7 December 2022

# Re: MLDRIN's Assessment of the 2022 version of the proposed New South Wales (NSW) Government's Lachlan Alluvium Water Resource Plan (WRP)

# Lachlan Alluvium Water Resource Plan (WRP) Assessment

Table 1: Comparison of Aboriginal cultural objectives across transitional, interim, and proposed WRPs for the WRPA

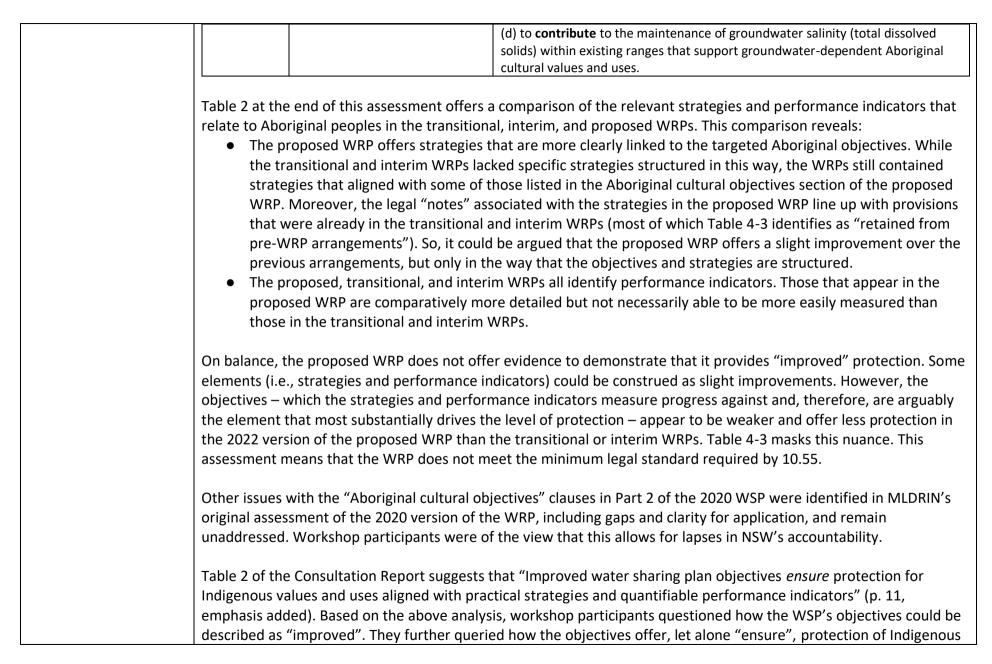
values and uses given they are derived from a standard template and are not fit for purpose and informed by consultation outcomes (see the earlier analysis of Tables 3 and 4 in the Consultation Report in the assessment of 10.52(1)(a)). Evidence is needed to confirm and justify such claims.
Overall, without evidence justifying NSW's claims that the 2022 version of the proposed Lachlan Alluvium WRP will maintain (let alone strengthen) the protection of Indigenous values and uses as described here, participants assessed parts of Table 4-3 to be misleading. Given these issues of transparency, participants were not satisfied that Table 4-3 could be relied on for addressing the minimum legal standard set by this Basin Plan requirement. MLDRIN recommends that the MDBA pay close attention to NSW's claims throughout the WRP and not just accept them at face value.
<ul> <li>(c) Inaccurate framing and misrepresentation of content</li> <li>MLDRIN and Nation representatives were disappointed that much of Table 4-3 in the 2022 version of the proposed WRP has been reproduced from the 2020 version without correcting the inaccurate framing and possible misrepresentation of protections already offered in MLDRIN's original assessment. Key examples are reproduced here in italicised text<sup>43</sup> (and, where necessary, updated): <ul> <li>Schedule 4(16) of WMA 2000 ("Land vested in a Aboriginal Land Council declared as exempt from the payment of rates and fees"): This statement is potentially misleading and open to misinterpretation. Not all lands vested in Land Councils are exempt; only land that is demonstrated to meet set criteria can be declared exempt, and this declaration only happens through application to the Minister.<sup>44</sup> The relevance to water, and specifically protection of Aboriginal peoples' water values and uses, is not articulated."</li> <li>s.55 of the WMA 2000 (native title): The WSP provisions referred to only accommodate native title water rights once a determination is made that native title rights exist but even then, such WSP provisions are yet to offer meaningful rights and protections to Traditional Owners with a determination. It is still unclear how much water native title holders can actually use."</li> </ul> </li> </ul>
